**CITY OF CHESTERFIELD
PLANNING COMMISSION MEETING
MONDAY – JANUARY 8, 2007
7:00 PM**

**PLANNING COMMISSION
OF THE CITY OF CHESTERFIELD
AT CHESTERFIELD CITY HALL
DECEMBER 11, 2006**

8. Clarify the subdivision map. Explain the map section surrounding area "129" where the City boundary line is.

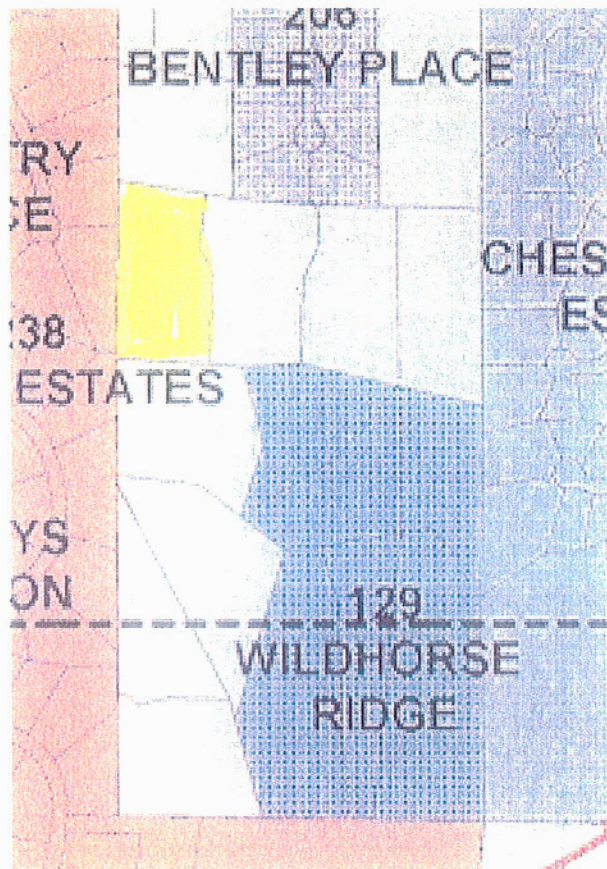
- ♦ What does "129 Wildhorse Ridge" stand for?
- ♦ Research whether "Wildhorse Ridge" refers only to the areas over "129".
- ♦ What do the dotted lines denote on the map?

8. Clarify the subdivision map. Explain the map section surrounding area "129" where the City boundary line is.

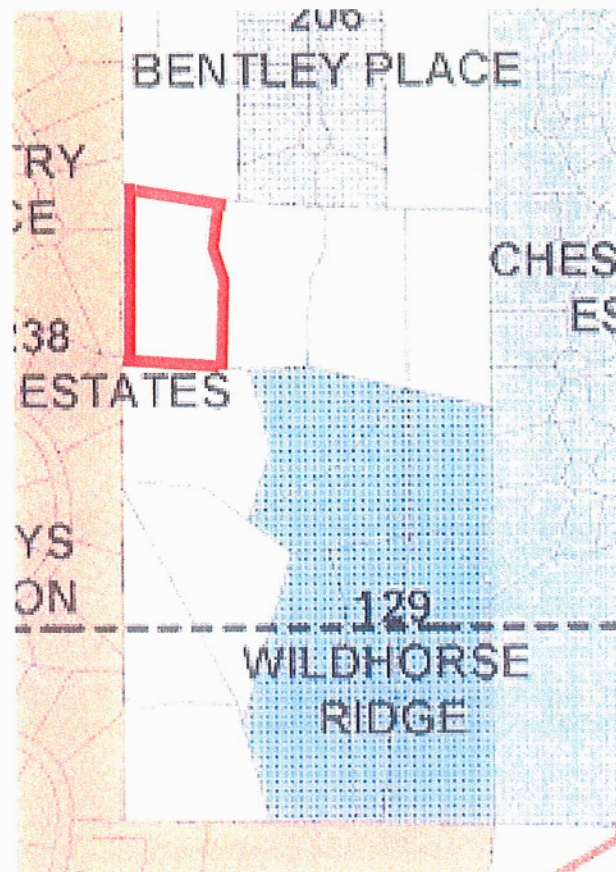
- ◆ What does "129 Wildhorse Ridge" stand for?
- ◆ Research whether "Wildhorse Ridge" refers only to the areas over "129".
- ◆ What do the dotted lines denote on the map?
